## Contents List

**A.P.4347L, Vol. 2**  
**Leaflet No. G.1**

**Hunter F.G.A. Mk. 11 Aircraft—Wings, Pylon Attachment Nuts**  
**Revised. Part (A) : Inboard Port ; Part (B) : Inboard Starboard ;**  
**Part (C) : Outboard Port ; Part (D) : Outboard Starboard**

(MOD. NO. HUNTER/964.)

DRG. No. A.P. 4347L | G | 61.

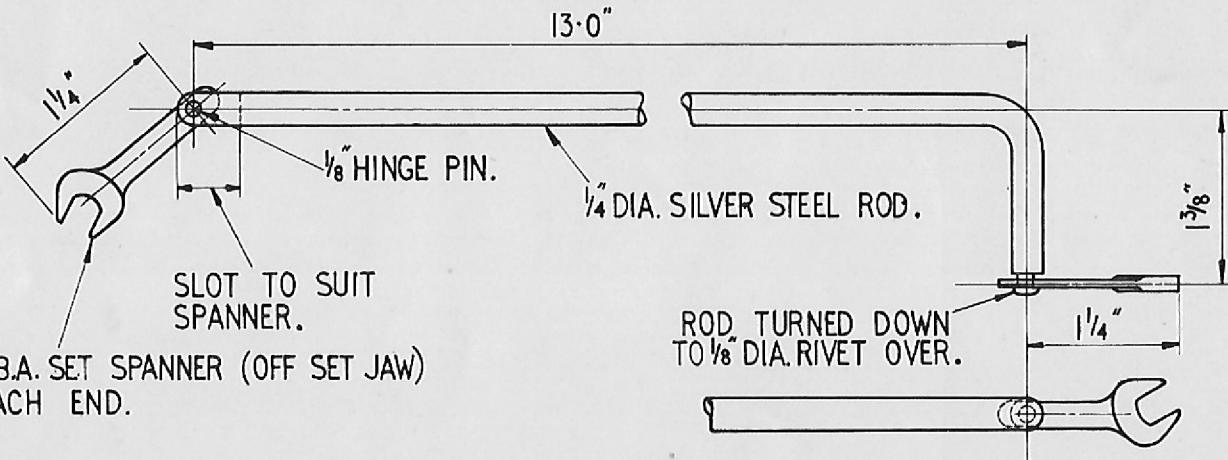
(8) Remove the eleven inboard pylon nut plates at positions shown on Drg. No. C.244737. To assist in dismantling old nut plates and assembling new nut plates, a tool similar to that illustrated on the drawing should be made from local resources.

(22) Remove the ten outboard pylon nut plates at positions shown on Drg. No. C.244932; those at "Detail B and C" by drilling out rivets through bottom skin. Care to be taken to avoid enlarging the rivet holes. To assist in dismantling old nut plates and assembling new nut plates, a tool similar to that shown on the drawing incorporated in this leaflet should be made from local resources.

TOOL TO ASSIST IN DISMANTLING AND ASSEMBLING NUT PLATES IN WING. MAKE FROM LOCAL RESOURCES.

Drawing No. A.P.4347L/G.4/63 is incorporated in this leaflet.

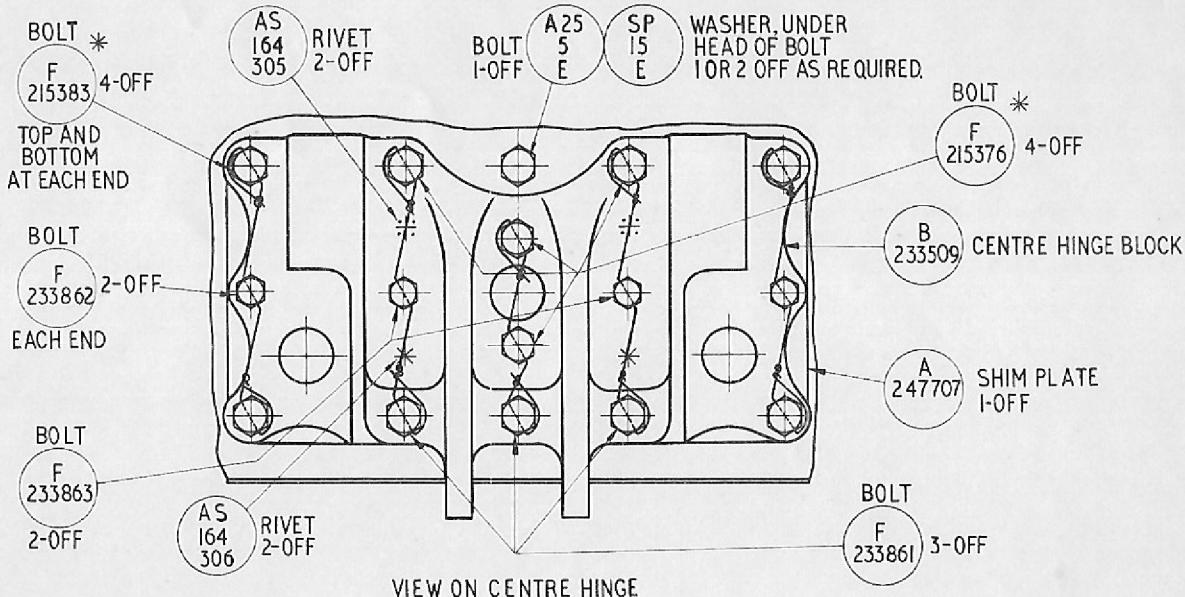
A stronger centre hinge block for the ailerons, manufactured from steel, has been introduced in place of the existing light alloy block to enable the centre hinge to withstand greater loads on the ailerons.

- (3) Carefully measure the thickness of the shim on L.A. Block if fitted, and fit to the new block, a new shim Pt. No. A.247707 after adjusting its thickness to be the same as the original shim, by peeling off as necessary. Refer to the drawing for riveting shim to block.
- (4) Fit new centre hinge block, Pt. No. B.233509 complete with shim plate, Pt. No. A.247707 to the aileron spar as shown on the drawing.

BOLTS TO BE WIRE LOCKED WITH 22G.  
STAINLESS WIRE SPEC<sup>N</sup> D.T.D. 189 OR D.T.D. 161.

DRG. No. A.P.4347L|G5|63

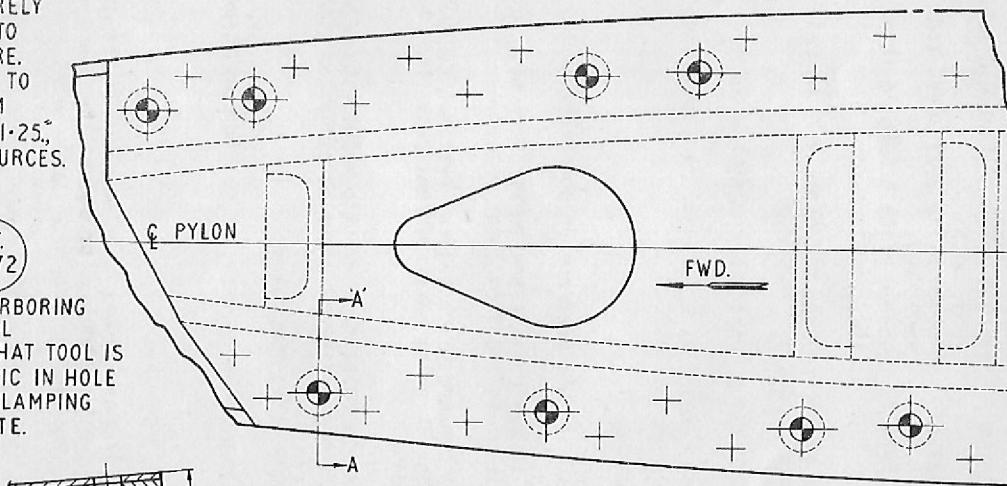
The depth of the counterbore in the pylon flange at the forward eight attachment bolt positions is increased to cater for material tolerances.

- (1) Refer to the drawing and manufacture stop plate with material obtained from local resources.
- (2) Modify inboard pylon angles, Part No. E.205825-8 or E.222077-80 using counterboring tool, Part No. S.T.2972 as shown.
- (3) Record the embodiment of this modification on the port and starboard inboard pylon modification plates.

STOP PLATE, CLAMPED SECURELY  
ON TOP OF PYLON IN ORDER TO  
LIMIT DEPTH OF COUNTERBORE.  
HOLE IN PLATE MORSE NO 10 TO  
CLEAR SPINDLE. MAKE FROM  
16 SWG. STEEL PLATE, 3.0" X 1.25",  
OBTAINED FROM LOCAL RESOURCES.

30°  
29". THIS DIMENSION TO  
APPLY AT ALL HOLES  
INDICATED THUS
